COUNTY OF SAN DIEGO
DEPARTMENT OF PLANNING AND LAND
USE
BUILDING DIVISION

SUPPLEMENTAL CORRECTION LIST – No. 12
Non-Residential Accessibility Regulations

*Elevators &
Special Access (Wheelchair) Lifts*

FIGURE 11B-40A—MINIMUM DIMENSIONS OF ELEVATOR CARS

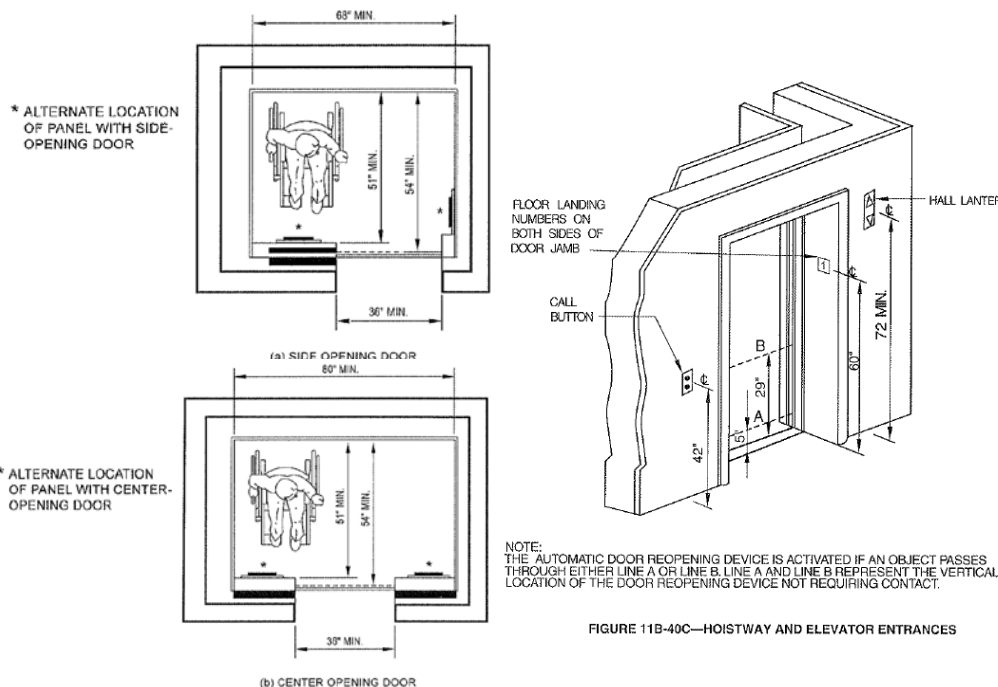
10. The car inside shall allow for the turning of a wheelchair. The minimum clear distance between wall or between wall and door, excluding return panels, shall not be less than:

a.) For center opening doors: 80 inches by 54 inches.

b.) For side-slide opening doors: 68 inches by 54 inches

11. Minimum distance from wall to return panel shall be 51 inches.

FIGURE 11B-40B—ELEVATOR CONTROL PANEL

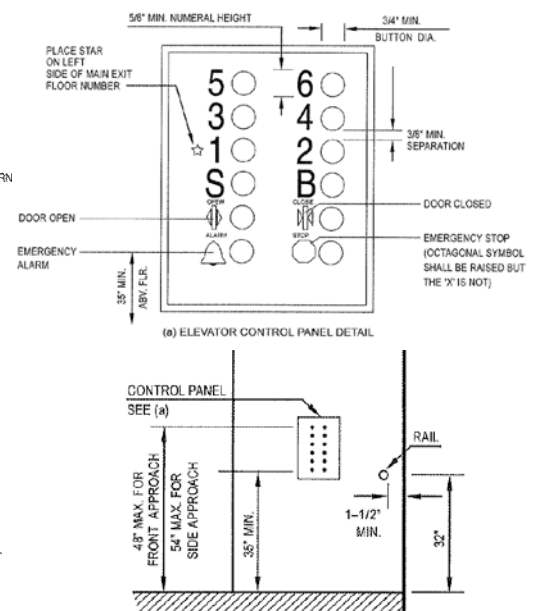
13. The centerline of elevator floor buttons for the car inside shall be no higher than 54 inches above the finish floor for side approach and 48 inches for front approach (where possible, a 48-inch maximum height for elevator floor buttons is preferred). Emergency controls, including the emergency stop and alarm, shall be grouped in or adjacent to the bottom of the panel and shall be no lower than 2 feet 11 inches from the floor. For multiple controls only, one set must comply with these height requirements. Controls shall be located on a front wall if cars have center opening doors, and at the side wall or at the front wall next to the door if cars have side opening doors.

a.) Car controls shall have a minimum dimension of $3/4$ inch and be raised $1/8$ inch ($\pm 1/32$ inch) above surrounding surfaces.

b.) Control buttons shall be illuminated, have square shoulders and be activated by a mechanical motion that is detectable.

c.) Control buttons shall be designated by $5/8$ inch minimum raised characters and standard raised symbols immediately to the left of the control button. Grade 2 shall be located immediately below the character or symbol. Minimum clear space of $3/8$ inch shall be provided between. Raised characters and symbols shall be white on black background.
